Title: FUEL CELL HYBRID VEHICLE WITH AUTOMATICALLY WATERED AQUEOUS BATTERIES

Inventor: Tartamella et al
Atty. Ref. 706403US1

Annotated Sheet

Fig. 1

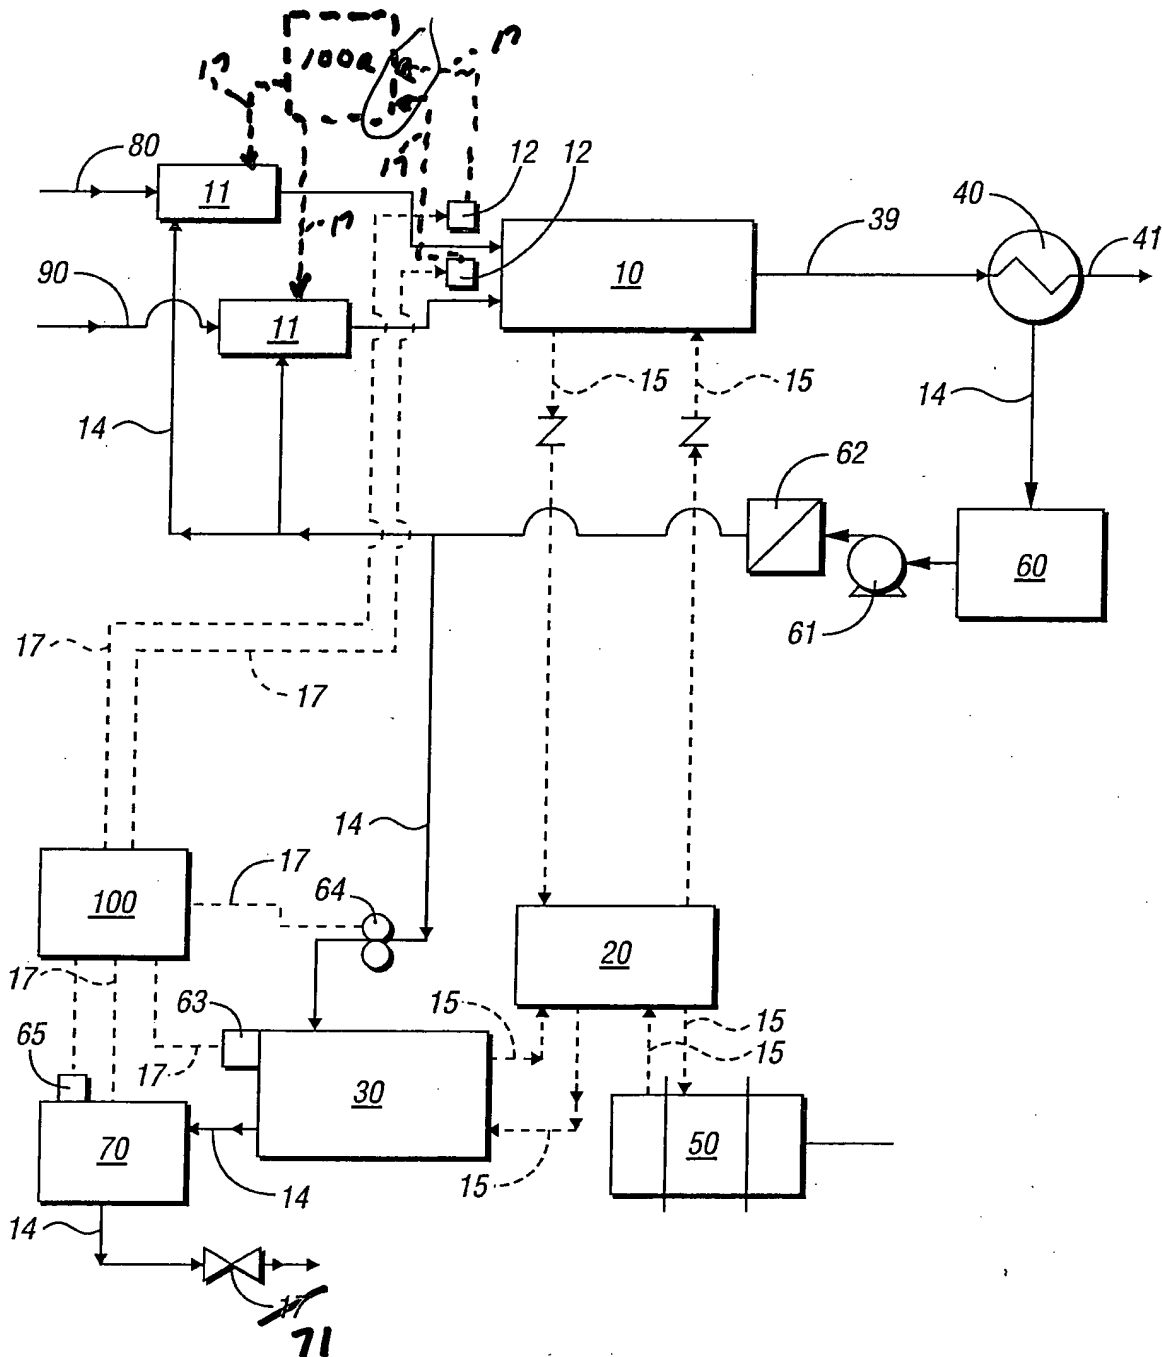
Valve reference number 17 at the lower portion of Fig. 1 has been replaced with 71, consistent with the specification at lines 14—16 of page 8.

The objection to reference numeral 12 as not being mentioned in the description is

incorrect. See the specification at line 1 of page 8 regarding “moisture sensors 12.”

An optional second controller 100a is now shown in phantom with signal lines 17 coupling controller 100a to moisture level sensors 12 (see the specification at line 1 of page 8) and humidifiers 11. The designation of the valve coupled to overflow reservoir 70 has been changed from "17" to -71—. See the specification at page 8, lines 14—16.
